Part 4 Technical Specifications and Bases

The U.S. EPR generic Technical Specifications and Bases, provided in Chapter 16 of the U.S. EPR FSAR are used to develop the {CCNPP Unit 3} Technical Specifications and Bases. Departures from the U.S. EPR generic Technical Specifications and Bases include replacing preliminary information provided in the brackets of the generic Technical Specifications and Bases with {CCNPP Unit 3} specific values and information, addressing and removing Reviewer's Notes, correcting typographical and editorial errors, and use of a Setpoint Control Program. These departures are addressed and justified in Section A of this part of the COL Application. Section B provides a complete copy of the {CCNPP Unit 3} Technical Specifications and Bases.

Section A – Departures

Figure 3.7.16-1 (page 1 of 1)

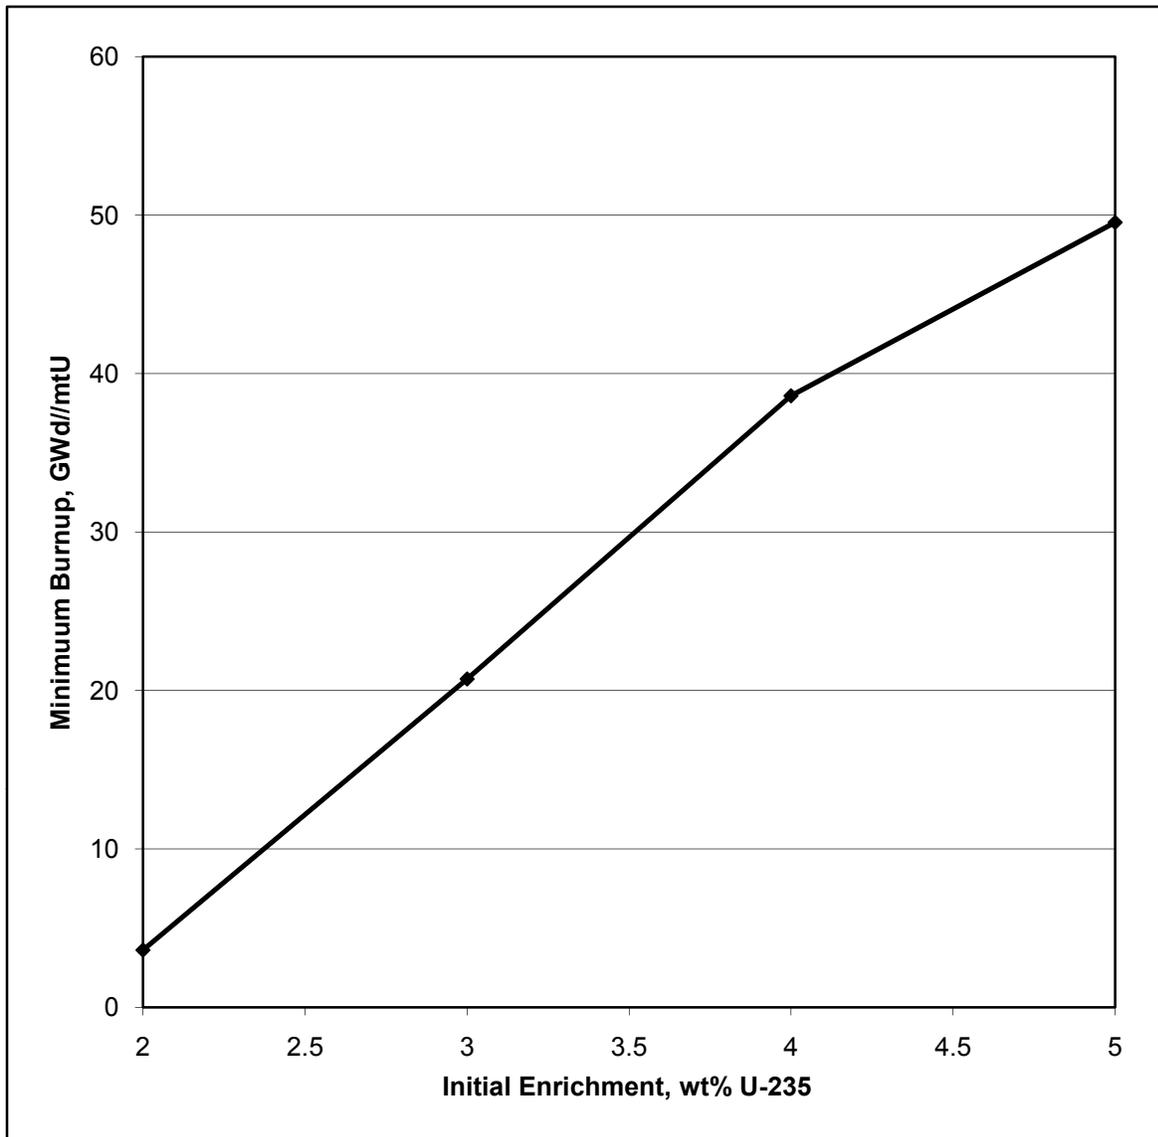
{CCNPP Unit 3} TS and Bases 3.7.16, "Spent Fuel Storage," are revised to remove the Reviewer's Note and include the {CCNPP Unit 3} specific spent fuel storage requirements in the TS and Bases, including the addition of Figure 3.7.16-1, "Fuel Assembly Burnup Requirements for Region 2." The associated Bases (all sections) are also revised to include a discussion of the bases for the specific spent fuel storage requirements.

LCO 3.7.16 ~~Fuel shall be stored in approved locations in the spent fuel storage pool.~~ The combination of initial enrichment and burnup of each fuel assembly stored in Region 2 of the spent fuel storage pool shall be within the limits specified in Figure 3.7.16-1.

The {CCNPP Unit 3} specific TS and Bases 3.7.16 are revised to reflect the results of the design and analyses of the {CCNPP Unit 3} specific spent fuel racks described in the Holtec Topical Report for the design and analyses of the U.S. EPR spent fuel storage racks.

Figure 4.3-1 (page 1 of 1)

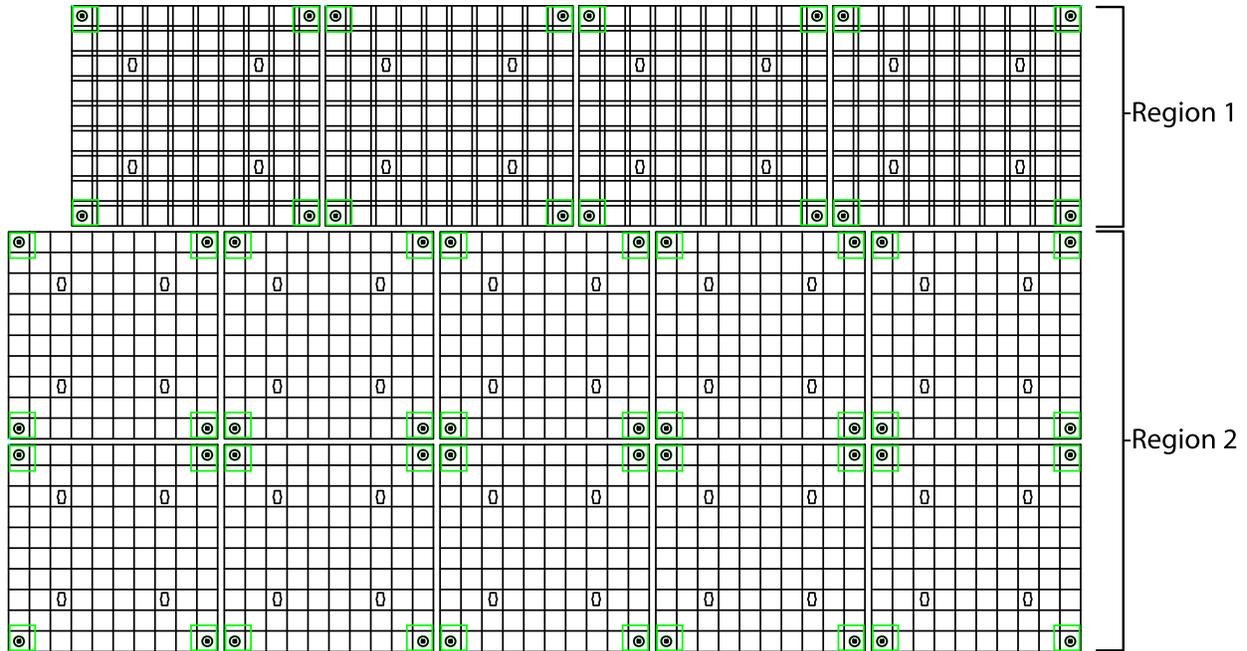
{CCNPP Unit 3} TS 4.3.1.1.c is revised to include the spent fuel rack center to center distances between fuel assemblies stored in Region 1 and for fuel assemblies stored in Region 2 of the {CCNPP Unit 3} spent fuel racks. In addition, restrictions on the storage of fuel assemblies are established in TS 4.3.1.1.d and 4.3.1.1.e. Figure 4.3-1, "Discrete Two Region Spent Fuel Pool Rack Layout" is added to identify the storage cells associated with Region 1 and the storage cells associated with Region 2.

d. New or partially spent fuel assemblies with any discharge burnup may be allowed unrestricted storage in Region 1 of Figure 4.3-1;

e. Partially spent fuel assemblies meeting the initial enrichment and burnup requirements of LCO 3.7.16, "Spent Fuel Storage," may be stored in Region 2 of Figure 4.3-1.

{CCNPP Unit 3} specific TS 4.3.1.1 requirements are revised to reflect the results of the design and analyses of the {CCNPP Unit 3} specific spent fuel racks described in the Holtec Topical Report for the design and analyses of the U.S. EPR spent fuel storage racks.
